Highgate CAAC objection to [HGY/2026/0813](#) for 64 Sheldon Avenue, N6 4ND

Construction of Single Storey Outbuilding and installation of 6 condenser units at rear; Landscaping and new Planting in front and rear gardens including tree removal; construction of new gates and replacement 1.8m fencing on side and rear boundaries.

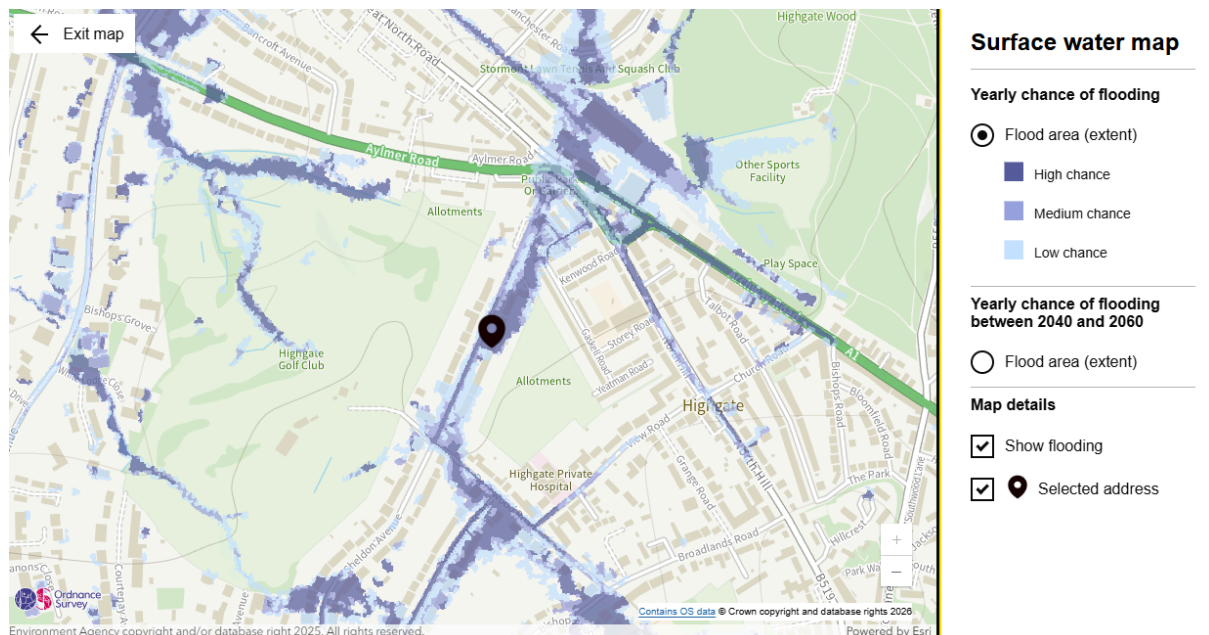
Highgate CAAC objects to this application for very similar reasons to our objection to earlier application [HGY/2025/3538](#) . We do not believe the observations of the case officer, conservation officer and HCAAC on that application have been answered, therefore this application should also be refused. In addition we believe the array of condensers bordering Highgate Allotments is excessive and unacceptable.
